**The City of Lake Forest
Building Review Board Agenda**

Agenda Item 3
710 Green Briar Lane
Revisions to Previously Approved Plans

710 Green Briar Lane

Consideration of a request for revisions to previously approved plans for a new residence on a vacant lot.

PREVIOUSLY APPROVED WEST ELEVATION

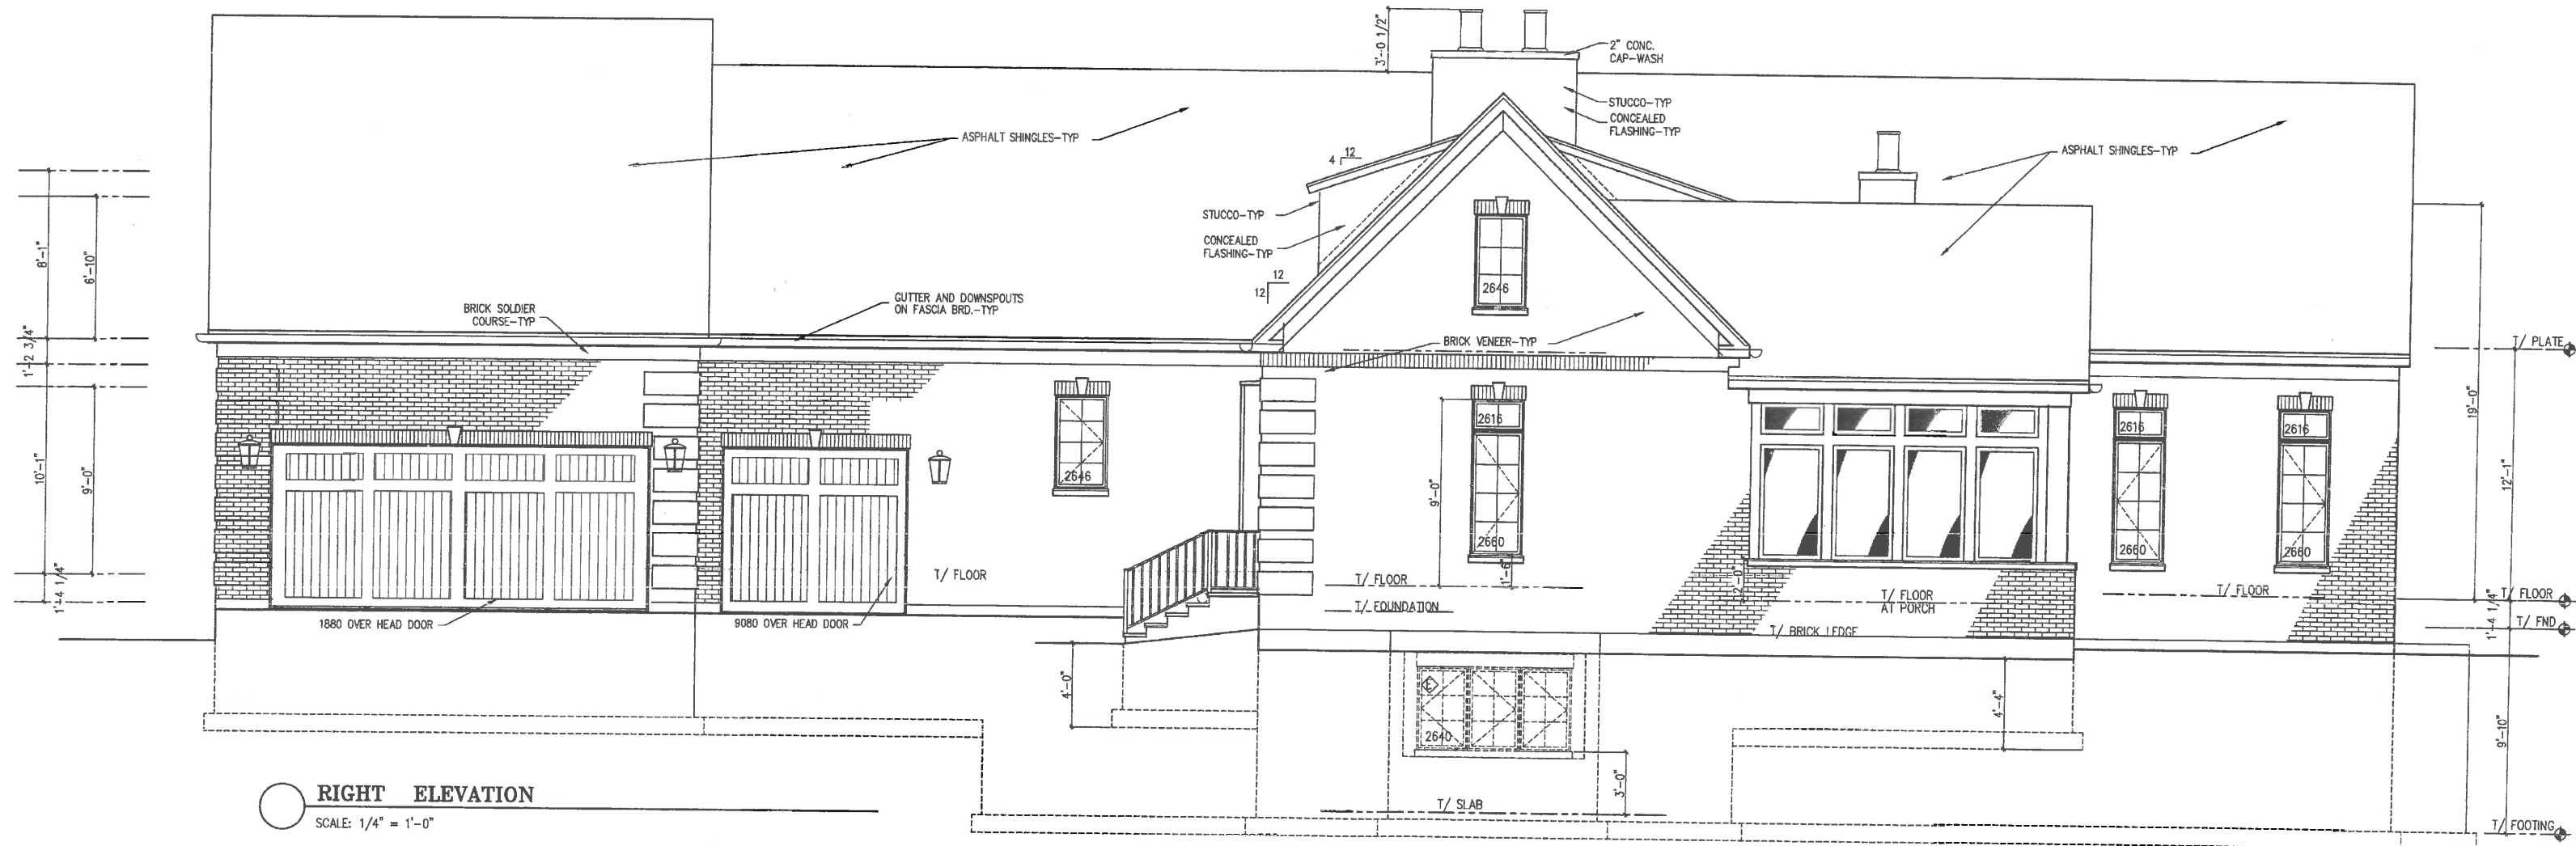
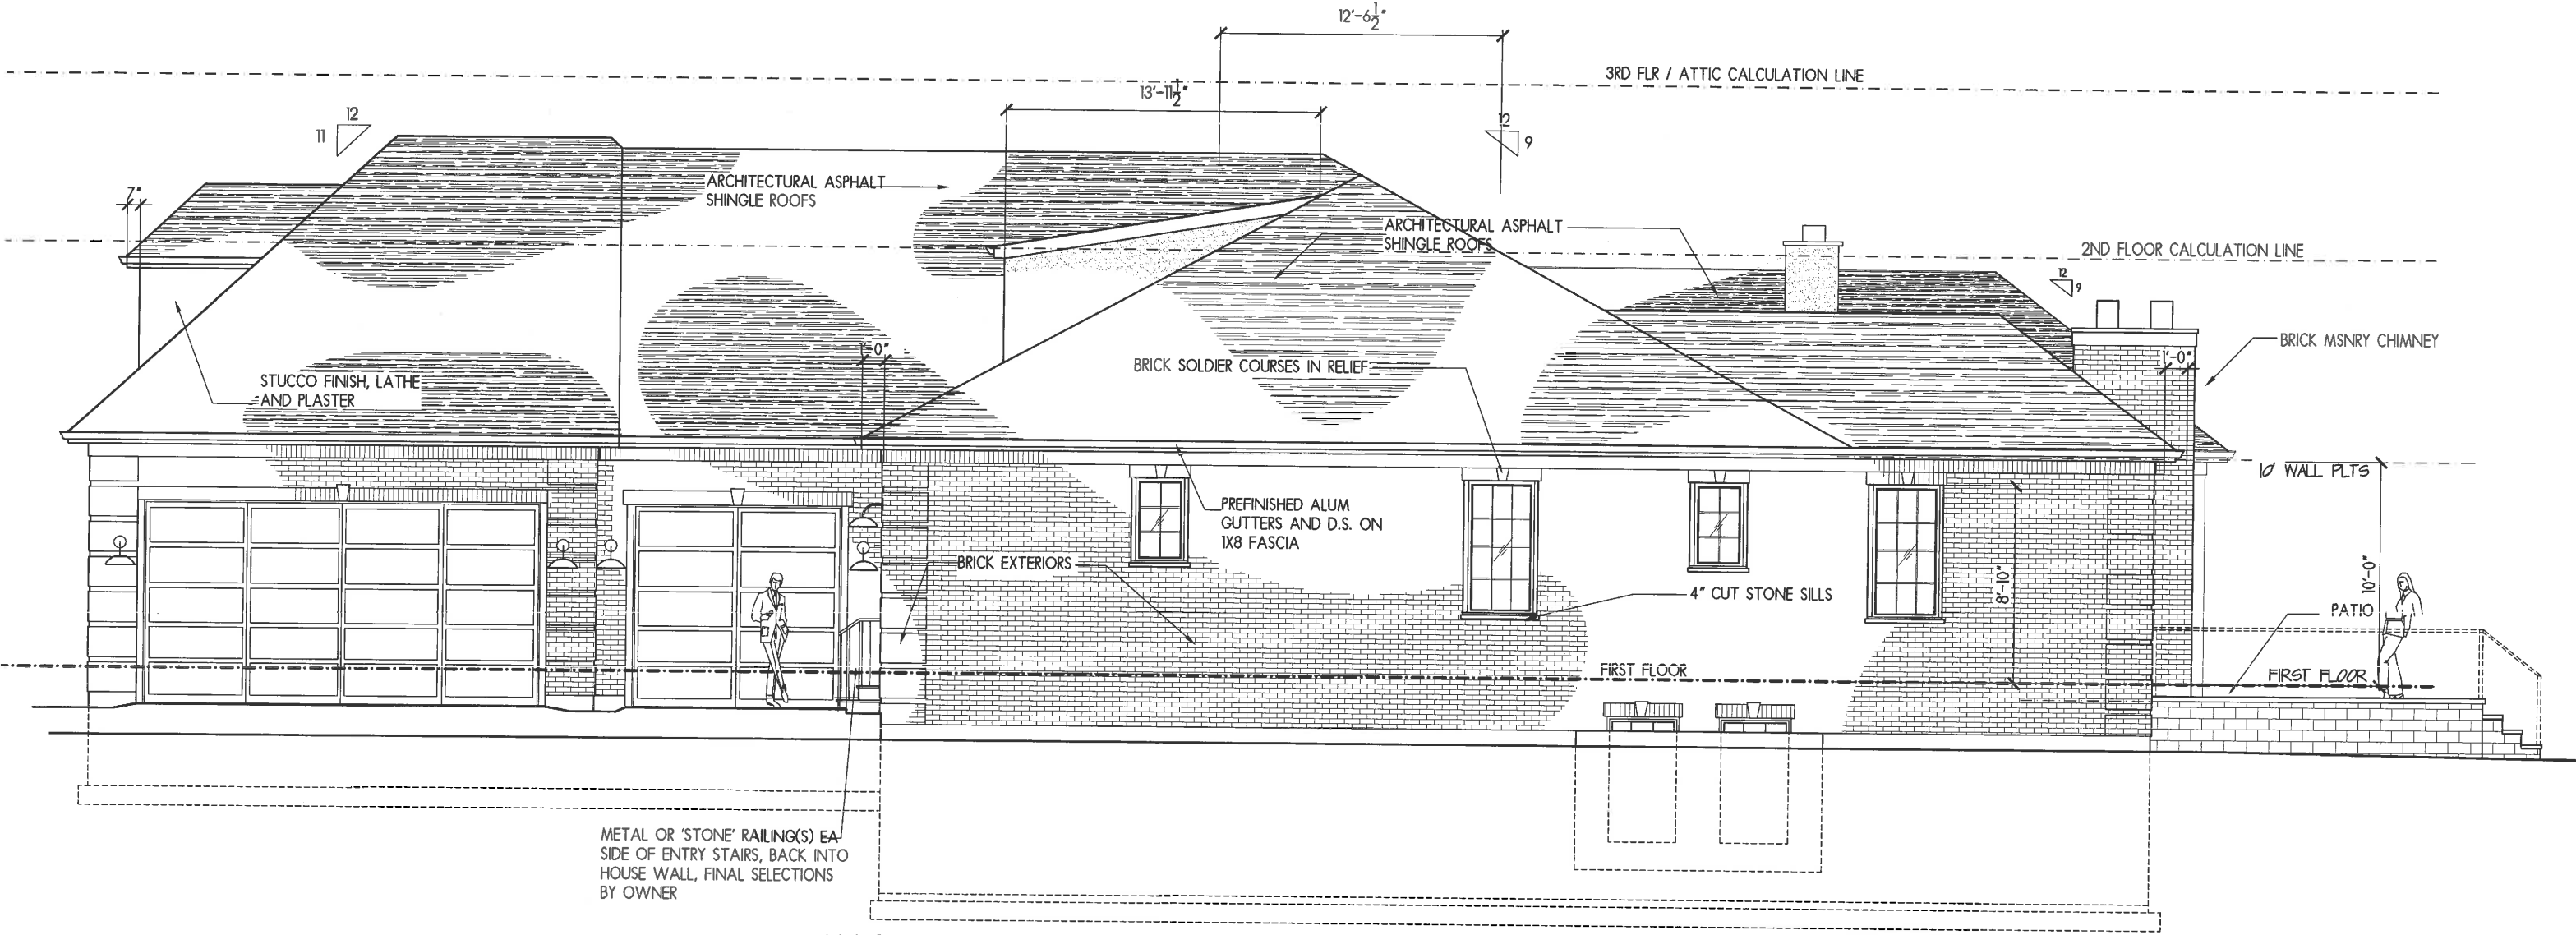
West Elevation

- The central gable element was removed from the elevation.
- The roof form on the west elevation presents multiple roof lines and pitches. The hip roof at the south end is an 11:12 pitch, the central hip roof is a 10.5:12 pitch, and the hip roof on the north end is a 9:12 pitch.
- One long shed dormer is now proposed instead of the two previously approved shed dormers on the elevation.
 - As currently proposed the shed dormer as it relates to the larger roof form appears complex. Board input on the proposed shed dormer is requested.
- The placement and proportions of the windows was modified.
